Addendum Number Five
To The Drawings and Specifications for
EMS Post #1
RFB Bid Number: 26-0035, Sedgwick County, Kansas

Issued: September 22, 2026

You are hereby instructed to include in your bids the following changes and/or corrections to the Drawings and Specifications for the **Construction of the New EMS Post #1 – 3099 W. 13th Street North, Wichita, Kansas 67203.**

SHEET
A8.3
OF 1 SHEETS

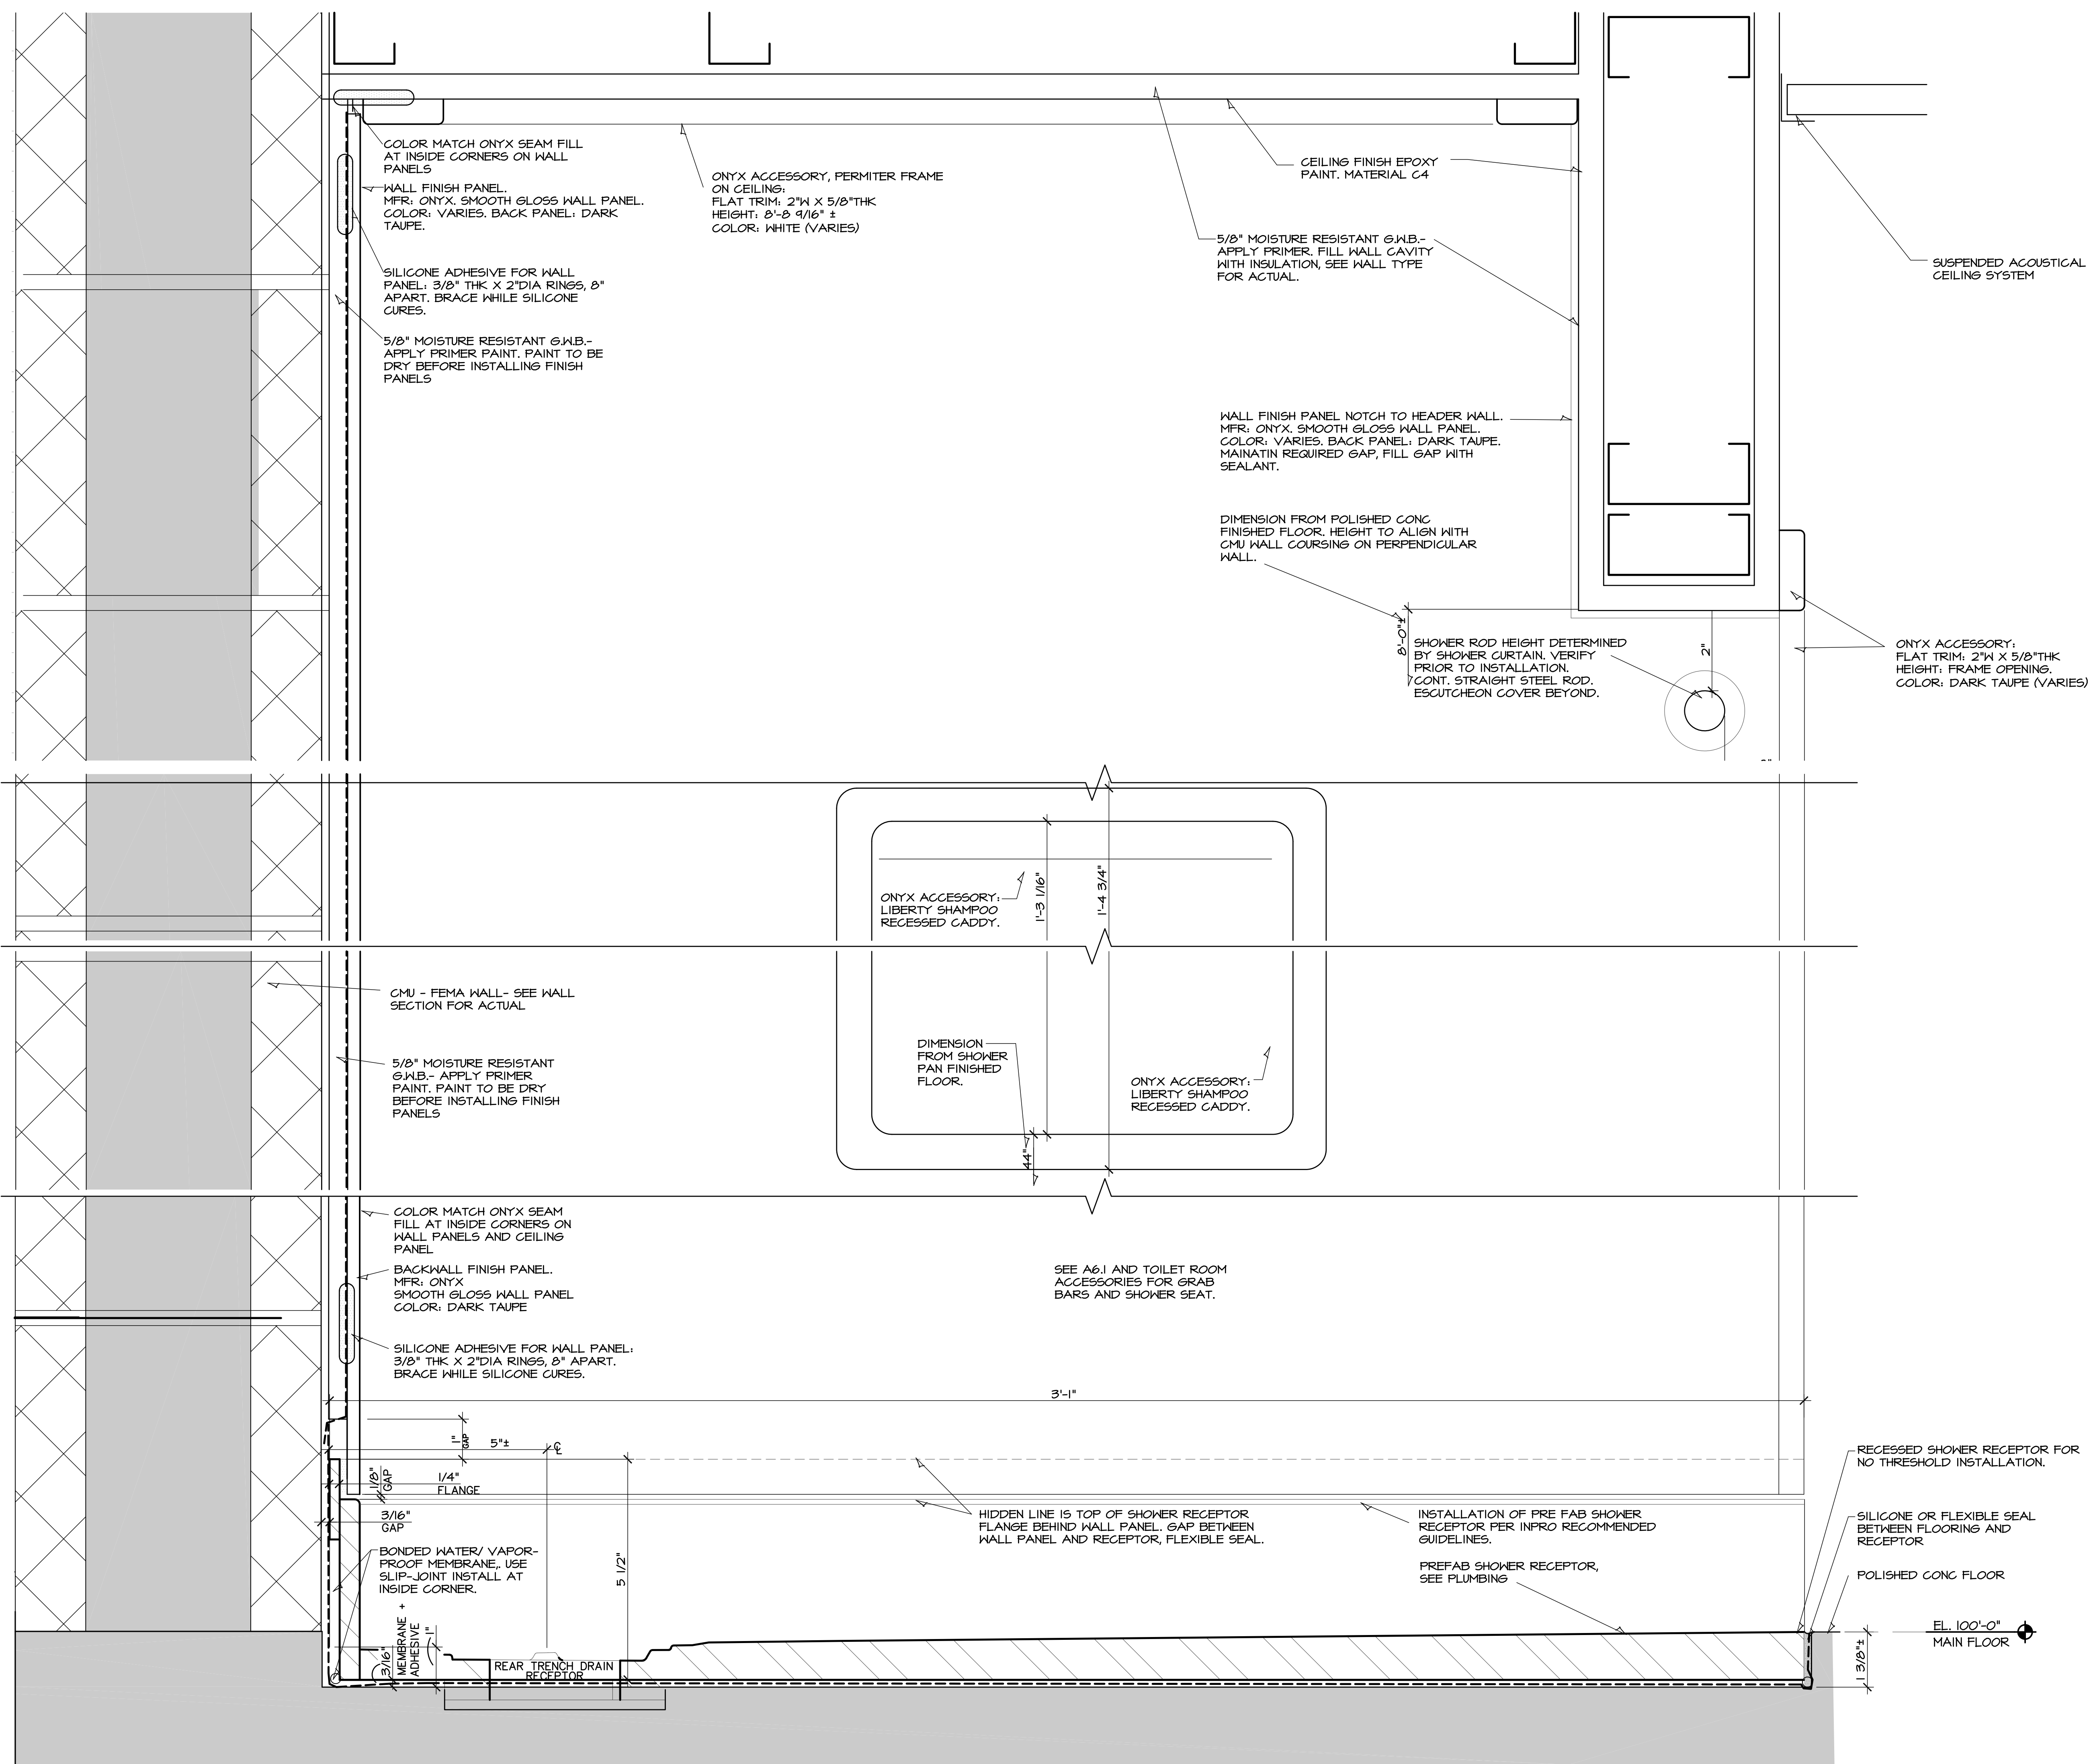
Distributor: Arizona Tile, Contact: Bobby Zink, phone (303) 574-2990,
email: bzink@arionatile.com
 3. Product is a rectangular sized tile,
Product: Reflexion (Reflex). Field Color: Mercury. Size: 12 inches x 24 inches.
Finish: Metallic sheen. Include matching porcelain bullnose trim, apply to exposed edges. Bullnose size 3 x 12. Installation is horizontally staggered. Color and install for bidding purposes, verify with architect prior to ordering.
 4. Schluter Metal trim applied to floor/ base joint. See detail 6/A8.1.
 5. Wall tile wainscot height as noted, 4 feet 9 inches. Field Tile: Start full sized tiles above floor/base joint. (4) full height courses. Accent Color, Continuous Horizontal Band, for Top (2) courses as follows: Cut tile height plus bull nose trim tile. Accent color: Titanium.
 6. Shower walls are as noted on A6.1, A8.2 and A8.3, issued by this addendum.

- 3.9 Sheet A6.1 + A6.2
The shower and finishes have been corrected.
These sheets are being reissued with this addendum.
- 3.10 Sheet A8.2 + Sheet A8.3
These sheets are being reissued with this addendum, detailing the shower.
